AMEC Project Number VM00448

**Reference: Mt. Polley Mine Tailings Facility  
Optimization Potential – Follow Up from Dam Safety Review**

**TSF Potential Optimization Workshop  
February 2007**

SECTION 1/1  
FIG. 2

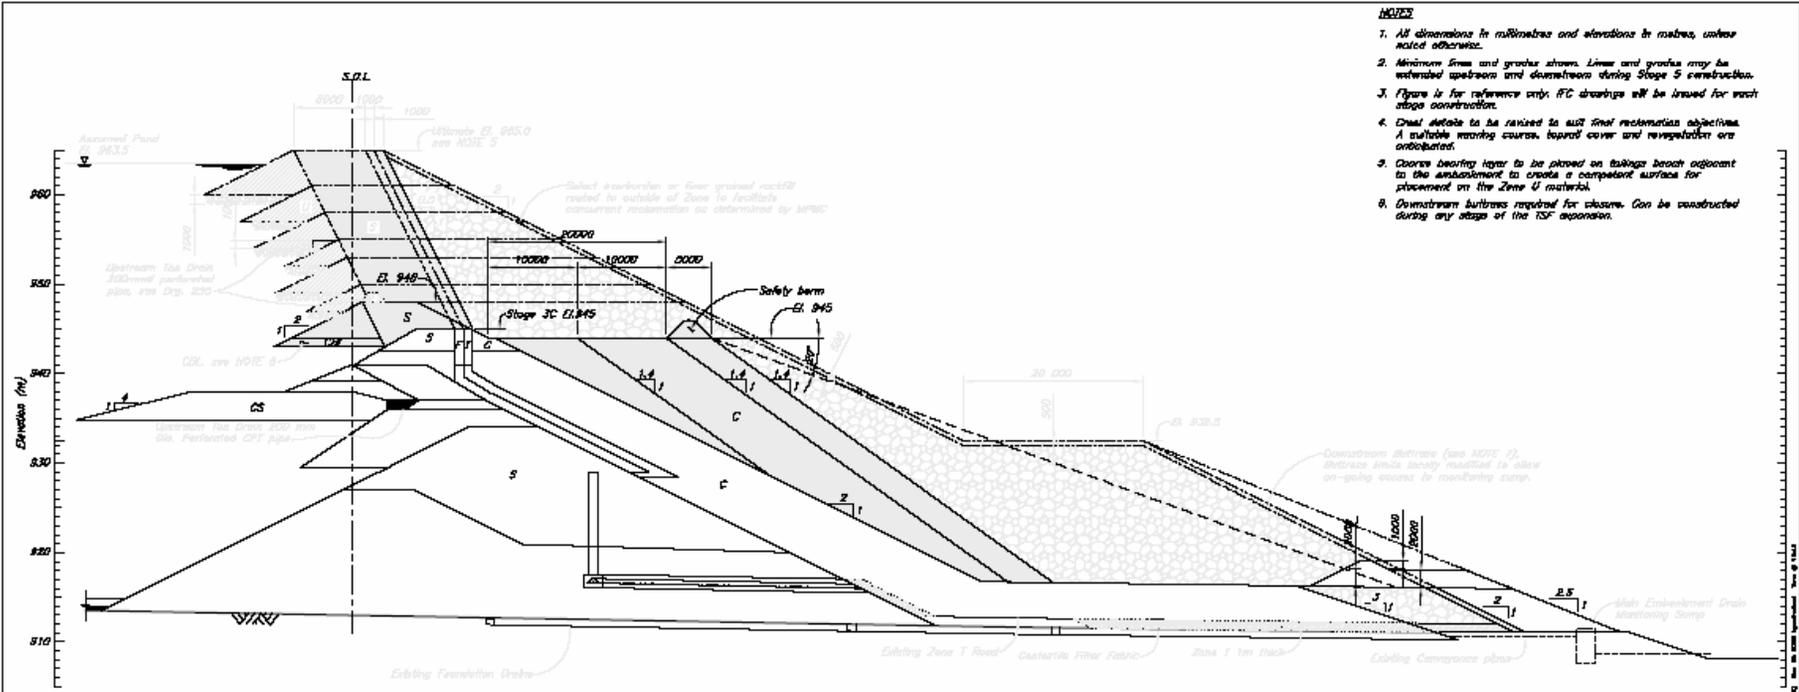
From our review we consider that there is a real opportunity to reduce the width of the core zone being stipulated for the raises moving forward. It is common dam engineering practice to narrow the core with height in the dam though there is a minimum thickness for the core (typically a practical construction consideration). The current core width of 8 m is certainly robust. Given the remaining projected height of dam construction to final elevation (assuming that the currently stipulated final elevation is not significantly exceeded), a decrease in core width should be considered for the 2007 raise and each raise thereafter. An acceptable rule of thumb is to have the core width be a minimum of 30% of the maximum head on the core; for example 20 metres of head corresponds to a 6 metre minimum requirement. The core could be further narrowed as the dam is raised in future, down to a practical minimum width of 3 m to 4 m.

Per the 2006 DSR report, it remains unclear to us why a buttressing berm has been specified for the closure geometry of the TSF. Provided that the foundation parameters are consistent with the glacial till reported in the documents to date, there should not be a foundation concern with the existing Main Embankment Dam geometry. The foundation strength parameters indicated in design documentation for the TSF to date and the current planned geometry without a berm would result in adequate stability conditions for operations and the closure condition.

The only uncertainty is the nature of the foundation soils regarding potential presheared planes of weakness. This issue was raised during the DSR but had not been noted in previous design documentation. If there is no such concern, as above, then there would appear to be no real need for the proposed berm.

Finally, if there is a valid reason for the berm identified the berm material need not necessarily be waste rock from the mine. All that would be required is an equivalent mass and, depending upon placement and geochemical considerations, even tailings may be an acceptable berm construction material.
